Product Change Notification

Change Notification #: 115969 - 00
Change Title: Intel® Server System HNS2600KPFR,
Intel® Server System HNS2600KPR,
Intel® Server System HNS2600TP24R,
Intel® Server System HNS2600TP24SR,
Intel® Server System HNS2600TP24STR,
Intel® Server System HNS2600TPFR,
Intel® Server System HNS2600TPR,
PCN 115969-00, Product Design, Change
node screw hole opening from round to oval
Date of Publication: November 30, 2017

Figure-1: Node screw holes locations (Front View)

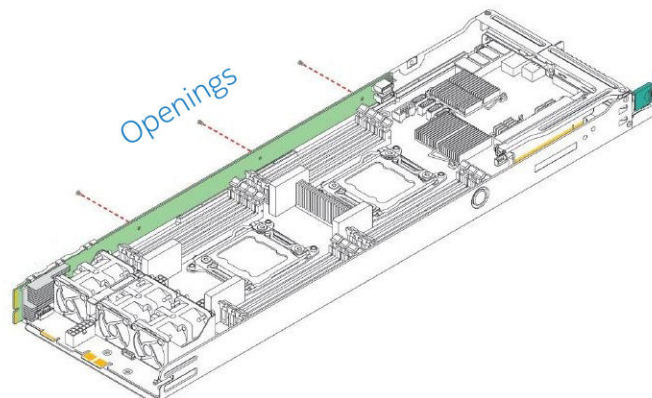
1. Change the screw hole openings of the node tray from round to oval shape to reduce the stress caused to the bridge board when assembling the node. Please see from Figure-1 to Figure-4 below for details
